**CCW IMPOUNDMENTS
INSPECTION REPORT**

**GORGAS STEAM PLANT
WALKER COUNTY,
ALABAMA**

**PROJECT No. 09-4157
SEPTEMBER 2009**

**CCW IMPOUNDMENT ASSESSMENT REPORT
WILLIAM CRAWFORD GORGAS ELECTRIC
GENERATING PLANT
WALKER COUNTY, ALABAMA
PROJECT NO. 09-4157**

FIGURE 3
 RATTLESNAKE DAM
 AND FEATURES
 GORGAS PLANT
 DAM SAFETY INSPECTION
 PREPARED FOR

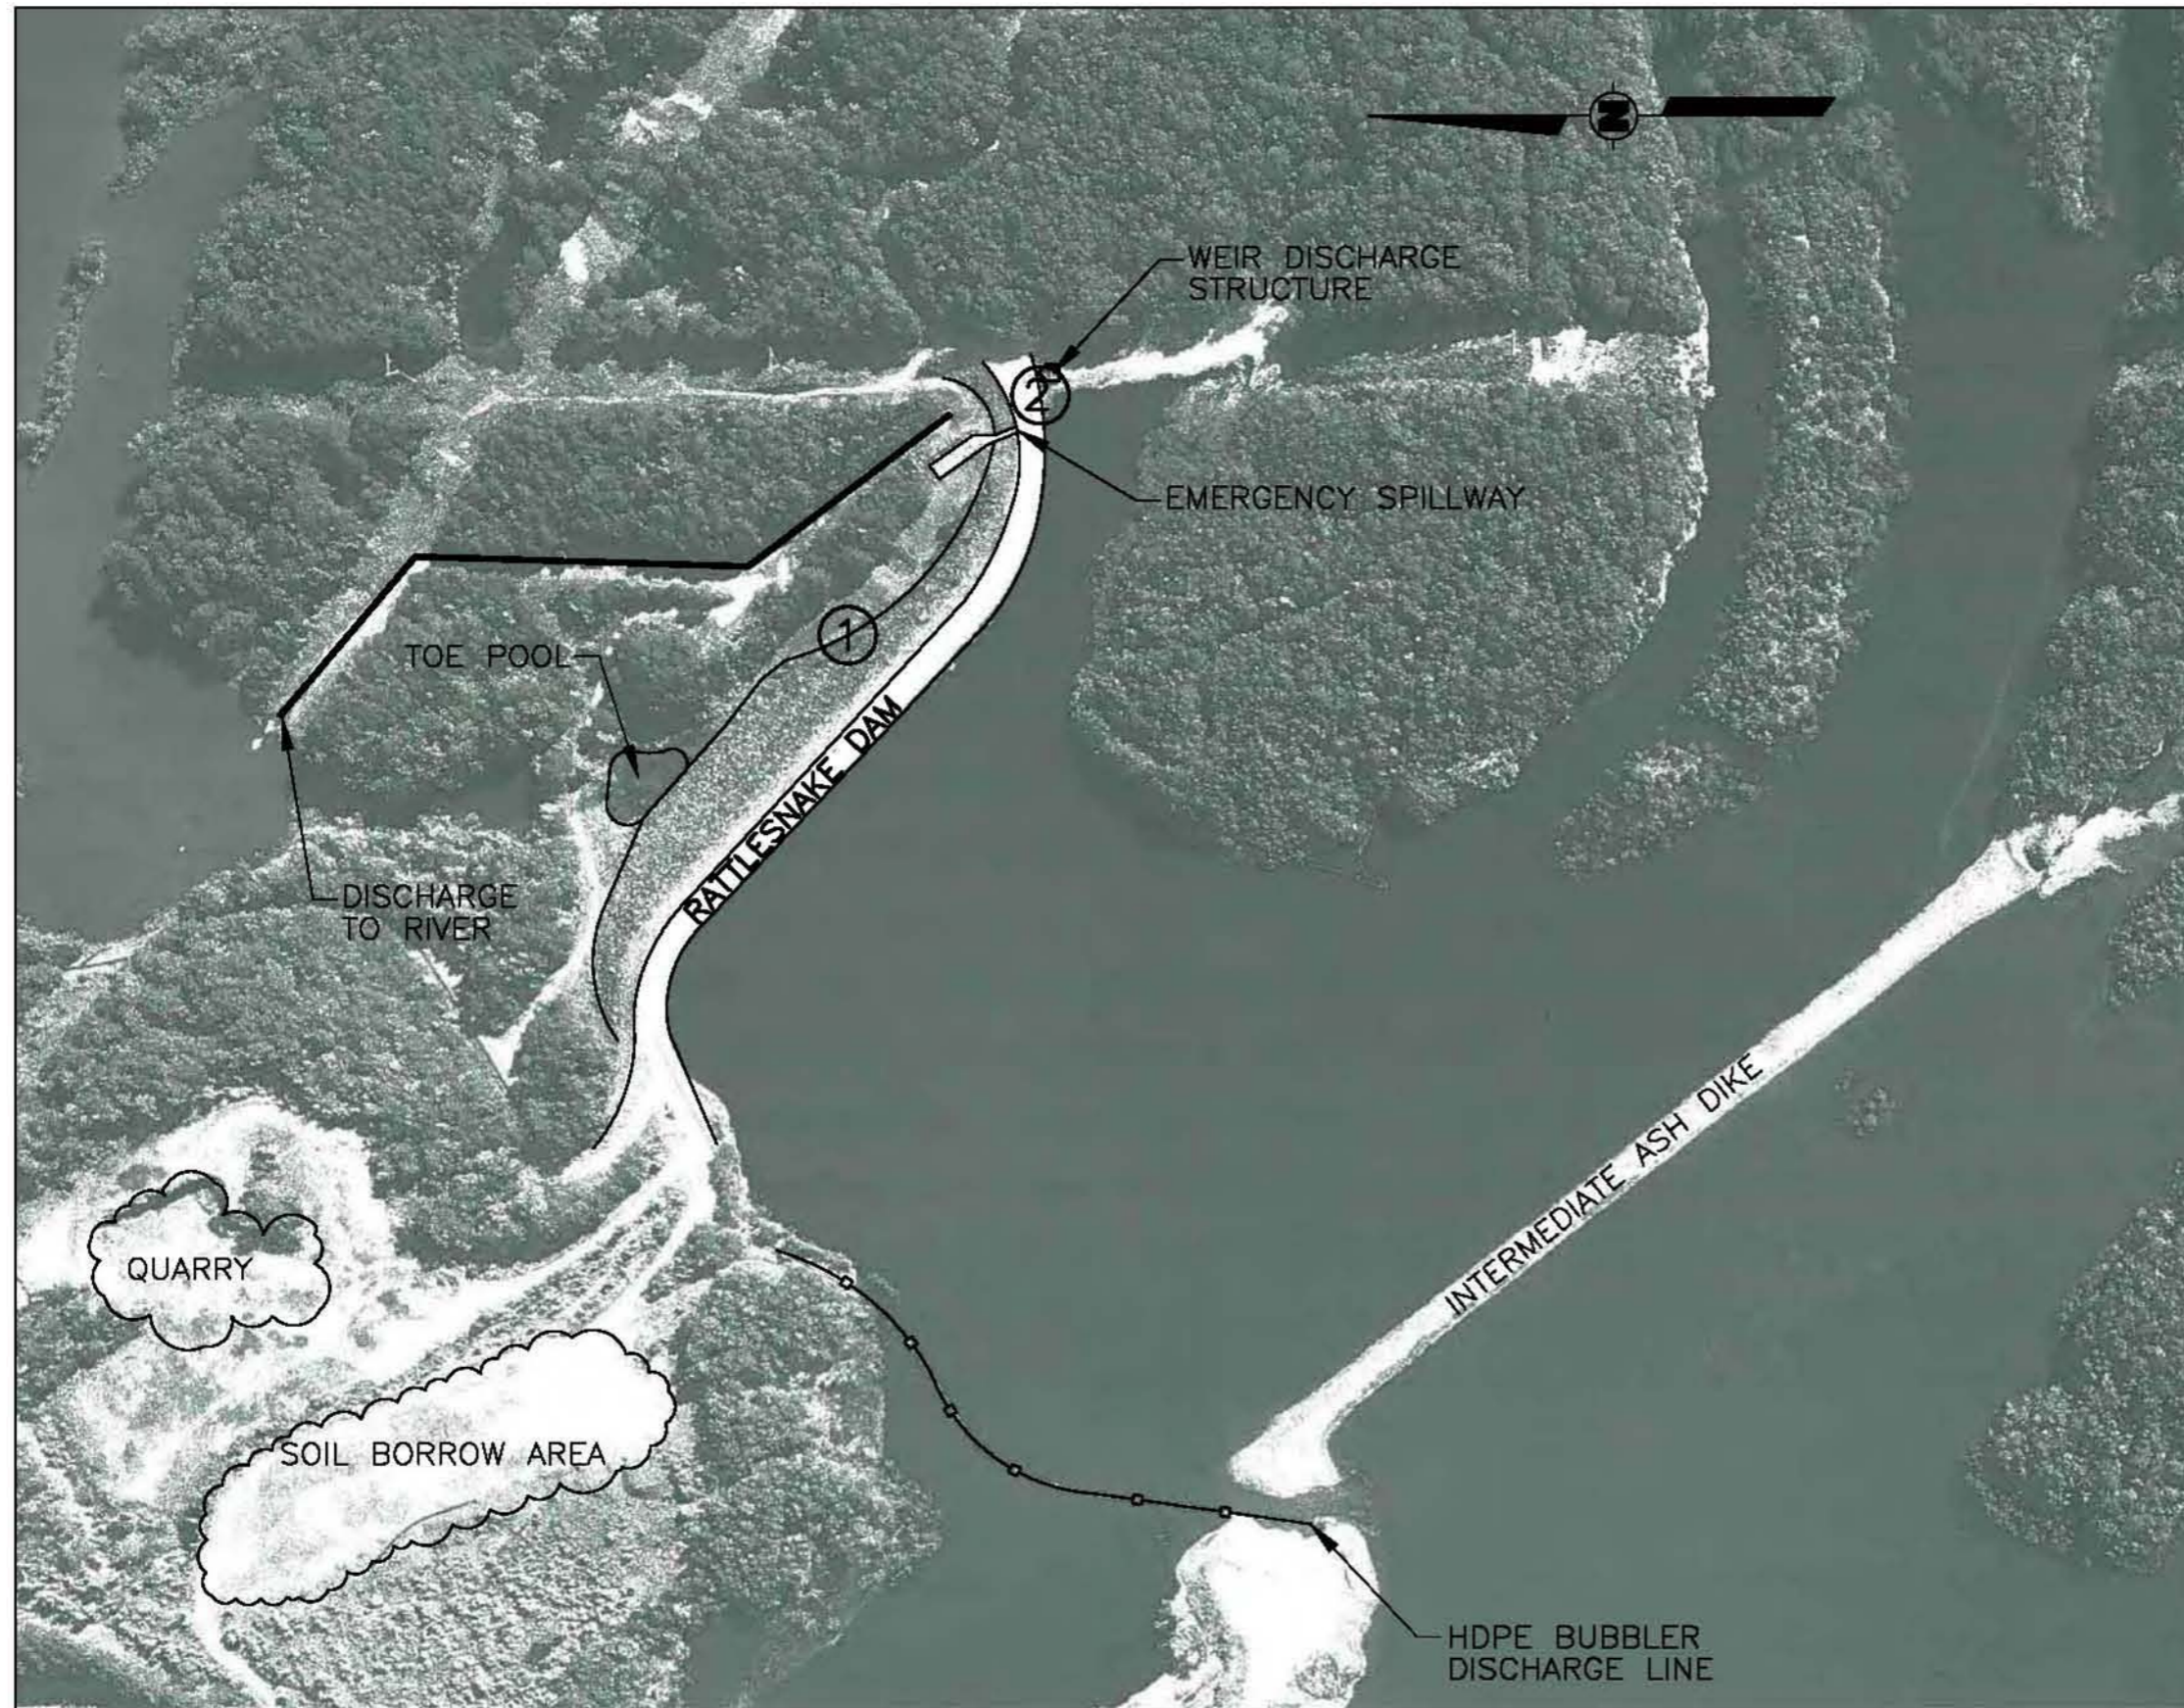
Vertical cracking was noted in the upstream face of the RCC near the intake weir and right abutment (*See Photo 6*). According to APC personnel, no construction joints were placed in the RCC facing between the abutments – a distance of approximately ^{redacted} feet. No area of concentrated vertical cracking was noted elsewhere on the RCC facing. The existing cracks should be monitored for change in size as part of the inspection program. The left abutment is flatter than the right abutment but may be subject to cracking due to future differential settlement. Observation of the front face of the RCC for cracking should be included in periodic inspection checklists.

The downstream toe is generally grassed and clear of trees and heavy vegetation, with the exception of areas of tall brush in areas difficult to reach with tractor mowers. Seepage was noted below the toe in the left abutment area. The area around the pond in the center portion of the dam appears to be continuously wet from seepage and tailwater from the river. The pond was built during the initial dam construction. Wet areas and standing

- ① APPROXIMATE LOCATION OF SEEPAGE FROM TOE.
- ② CRACKING IN RCC FACING BLOCK NOTED HERE.

In conjunction with Recommendation No. 1, the existing weir box at the toe of the downstream slope of Rattlesnake Dam should be cleaned out and repositioned, or replaced with a larger weir if necessary, to collect the seepage flow along the downstream toe observed at the time of inspection. As much of the seepage currently visible should be collected as possible and the small ditch creating the current flow path should be kept as clear as possible to facilitate observations of changes in volume, turbidity, or location of new seeps. Such information, along with the flow measured at the box should be recorded as a part of Recommendation No. 1, so that seepage trends can be established and reviewed easily. In the event of increased seepage flows, the installation of additional instrumentation and a more involved monitoring program may be warranted.

It is recommended that cracks in the RCC facing block of Rattlesnake Dam be monitored as they develop, and that remedial measures such as caulking or grouting be considered to treat the cracks if they are deemed a risk to the embankment materials during normal conditions or high pool events.
